Technical Memorandum

SUBJECT: Review of High Timber Resources, L.P. Simsboro Aquifer Evaluation Report

DATE: July 3, 2023

Figure 5:
1-Year QCSP GAM
Drawdown Contours

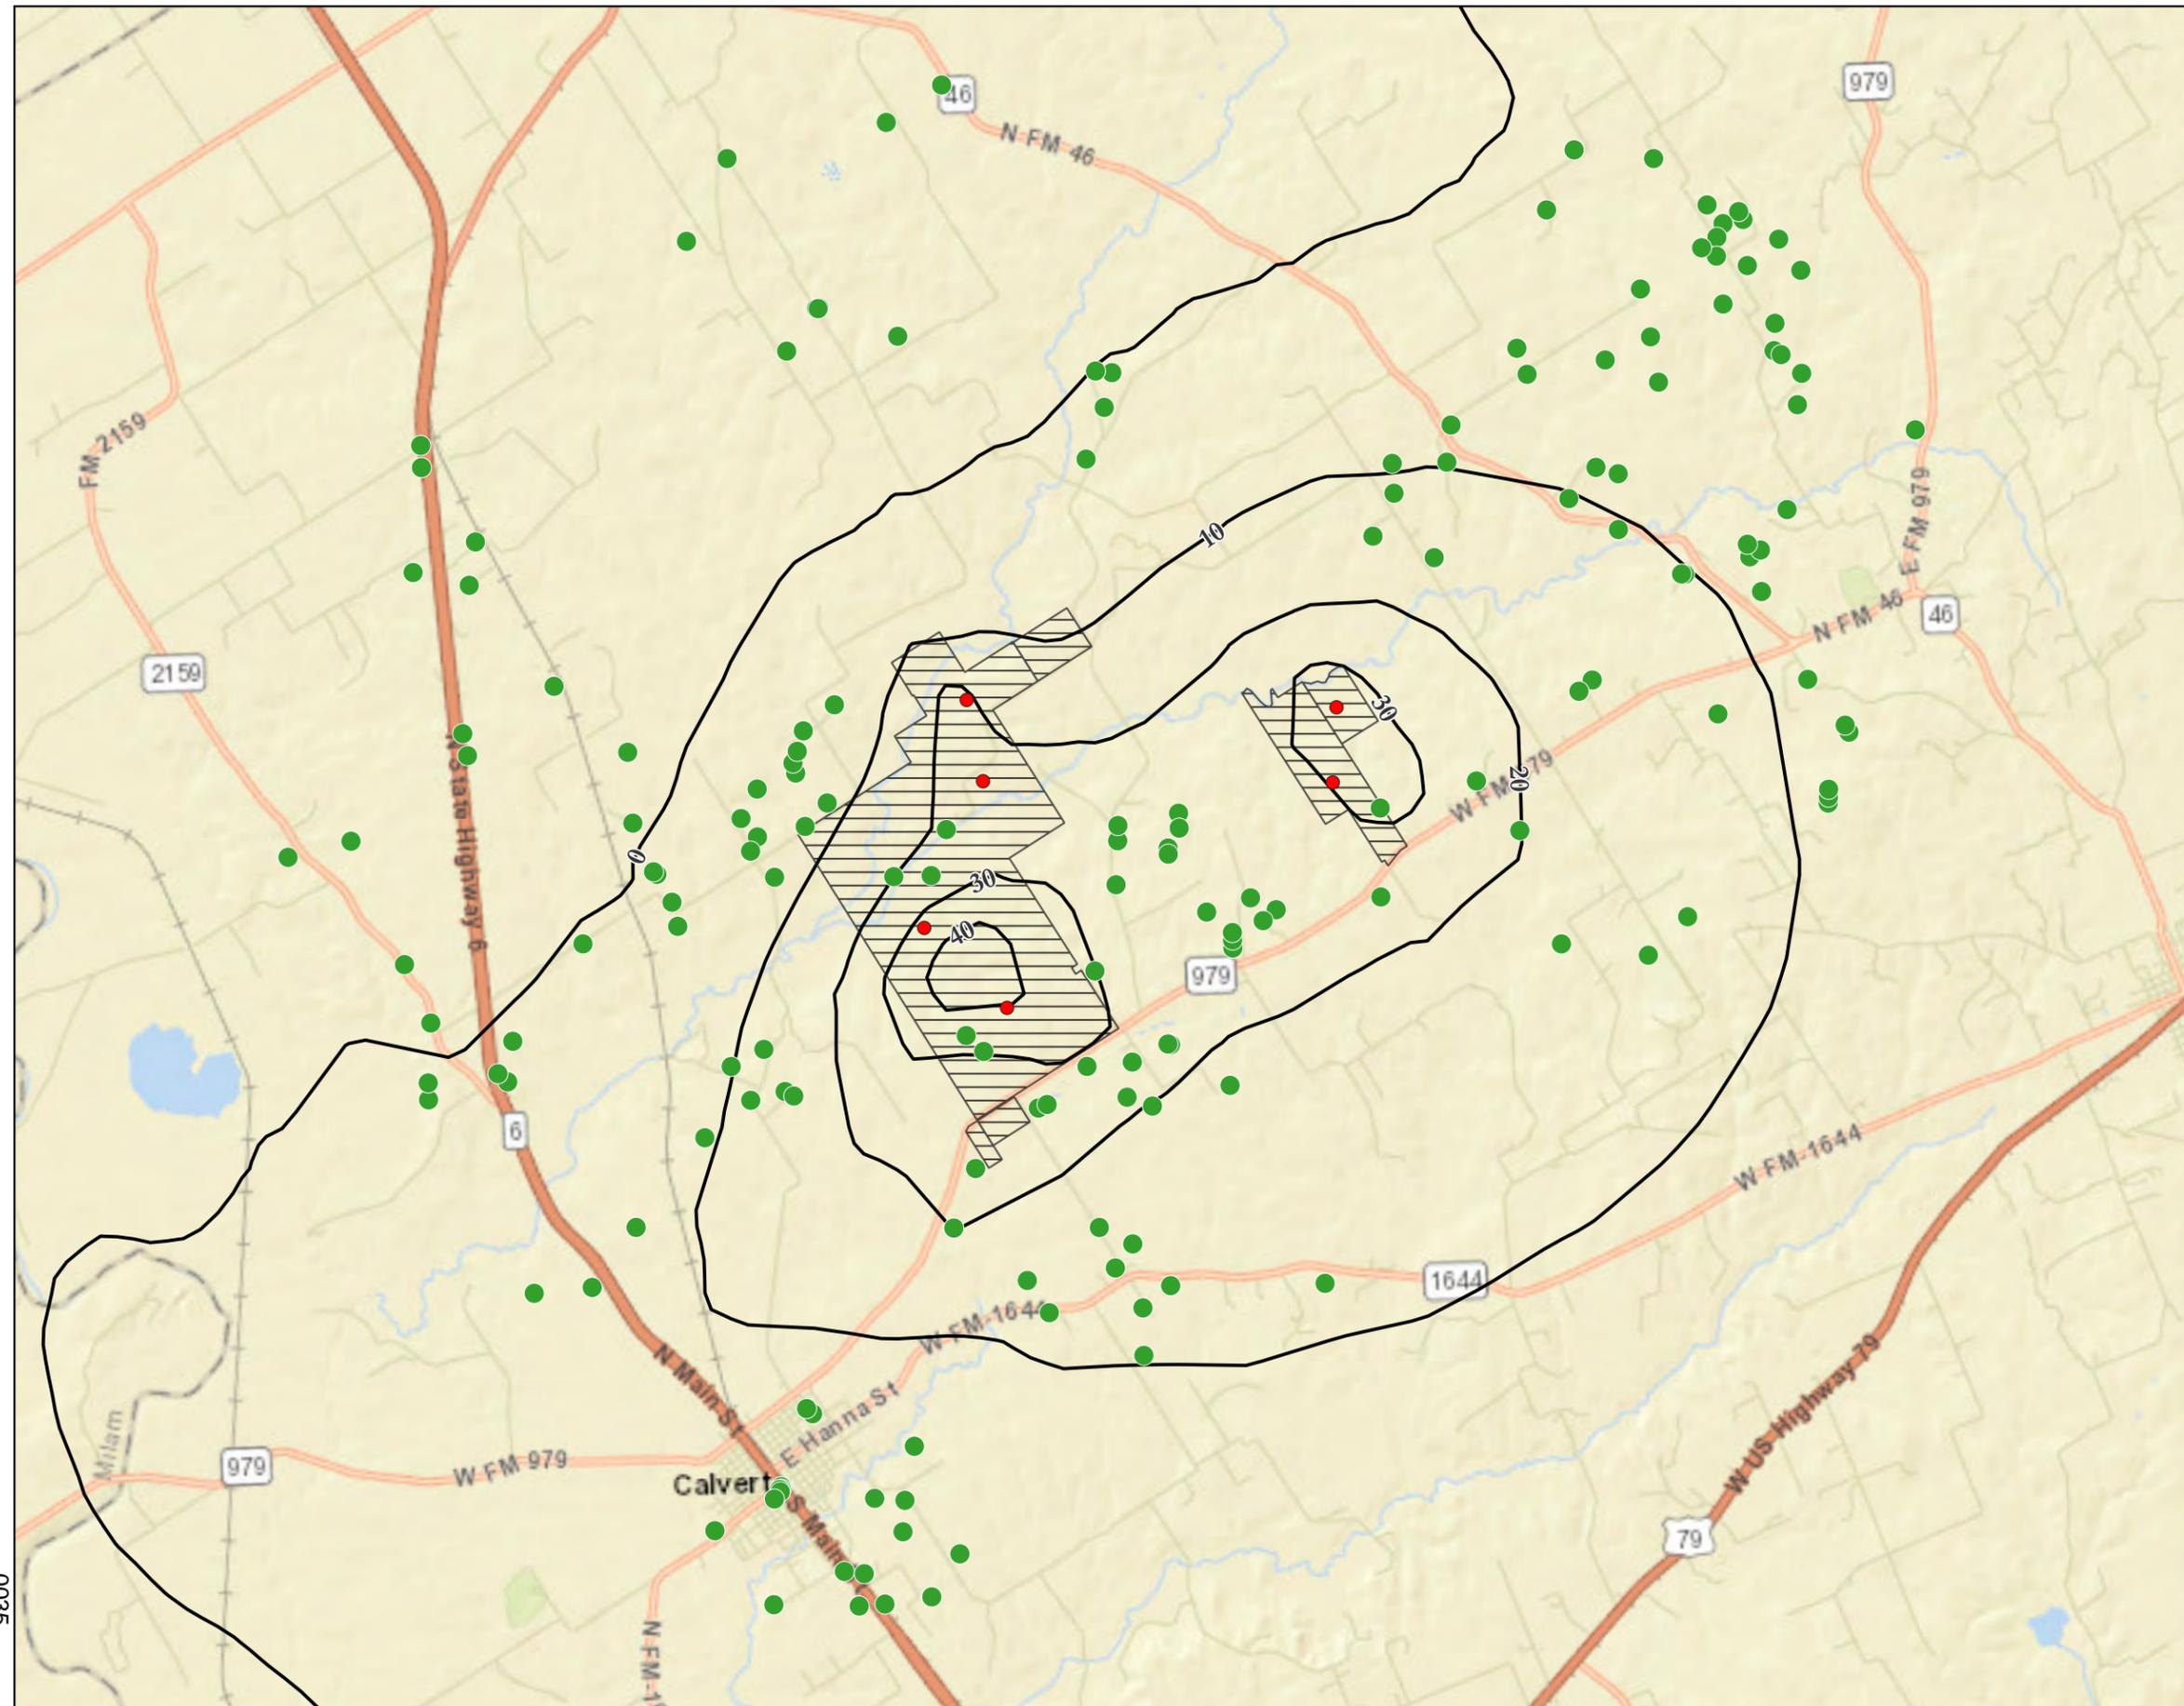
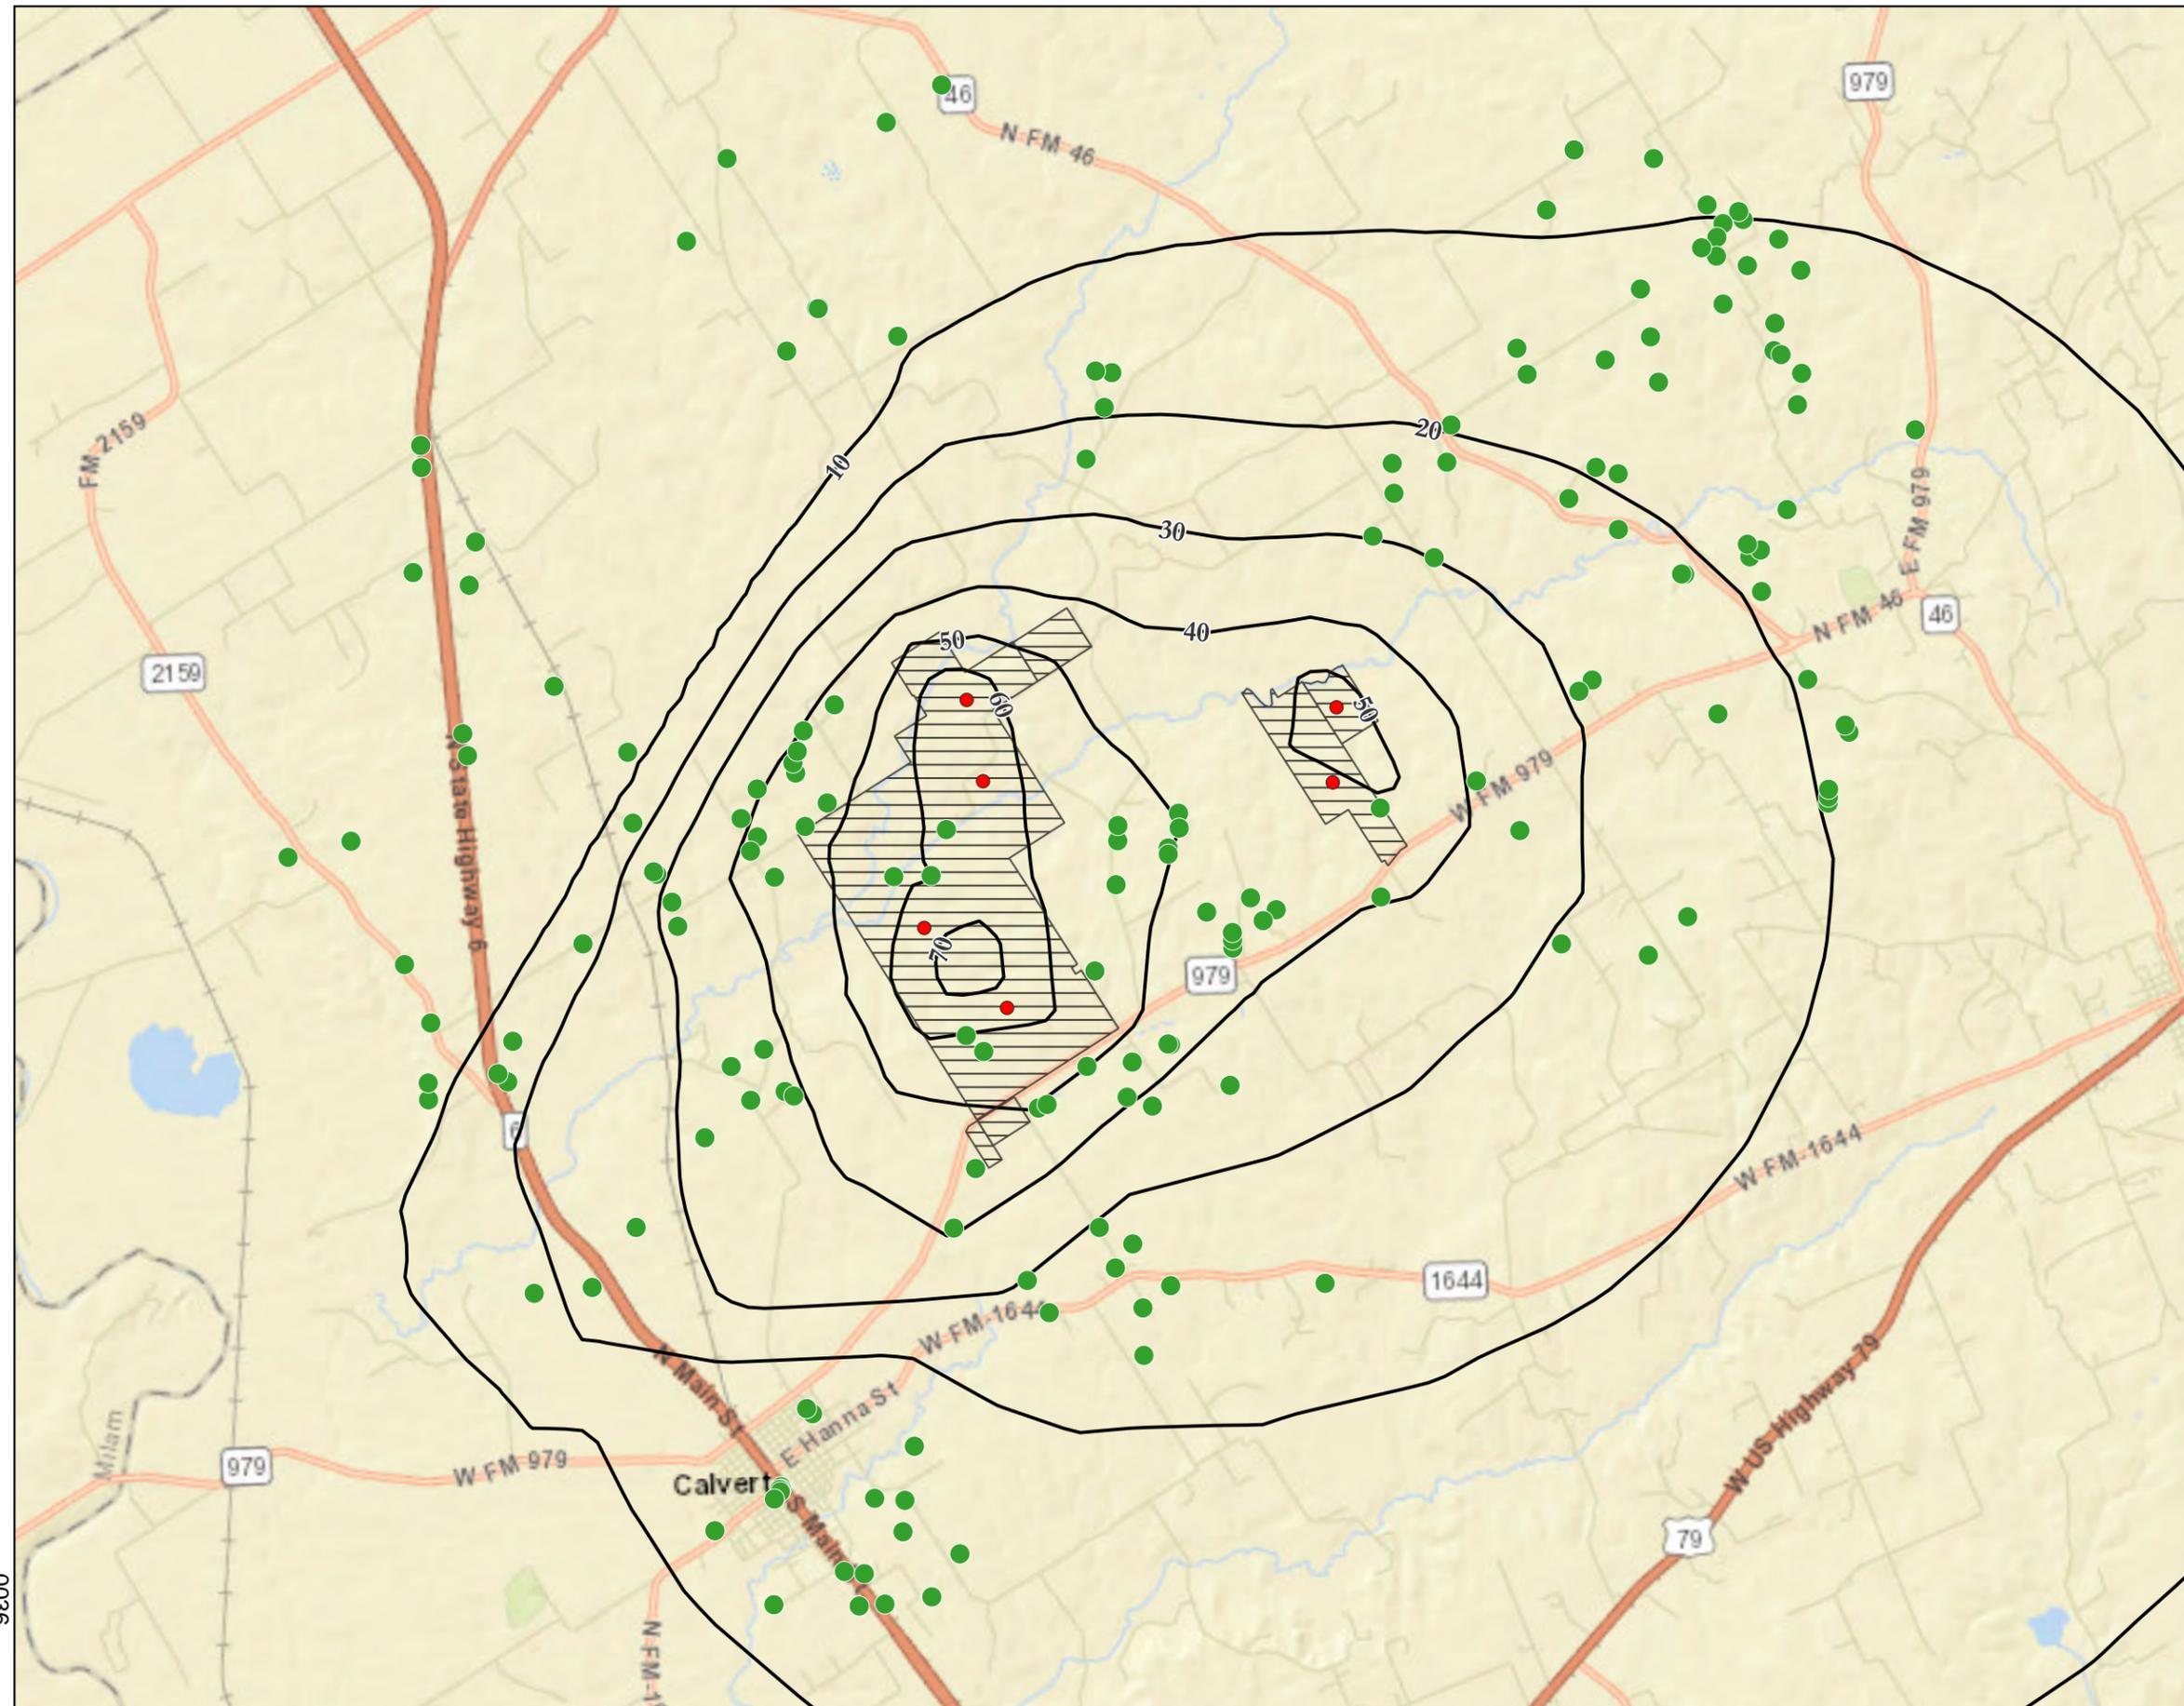
TGI used the TWDB Central Portion of the Sparta, Queen City and Carrizo-Wilcox Aquifer GAM to estimate drawdown that results from continuously pumping the proposed High Timber wells at a combined rate of 11,870 ac-ft/yr for 1 year and 10 years. A copy of the TGI 1-year and 10-year GAM simulated interference drawdown illustrations from the AER (TGI Figures 5 and 6) are attached to this memorandum. Table 1 in the TGI AER shows GAM simulated 1-year and 10-year drawdown estimates at BVGCD permitted and registered Simsboro wells within a five-mile radius of the proposed wells. The TGI report did not discuss the GAM simulation methodology, but the GAM model results generally appear to be reasonable based on AGS simulation verification runs.

The AGS GAM simulation results after 1 and 10 years of pumping 11,870 ac-ft/yr generally show drawdown estimates to be slightly less than the TGI drawdown estimates at all of the proposed High Timber well locations. The slight drawdown differences between the AGS and TGI runs

could potentially be attributed to background pumping in the TGI simulations if TGI did not use the approach described above to isolate the drawdown.

The GAM estimated drawdown contours near proposed High Timber Wells 1 through 4 appear to be influenced by faults included in the GAM, which are in the same general area as faults that have been mapped by GWC and AGS using local geophysical logs and other hydrogeologic data.
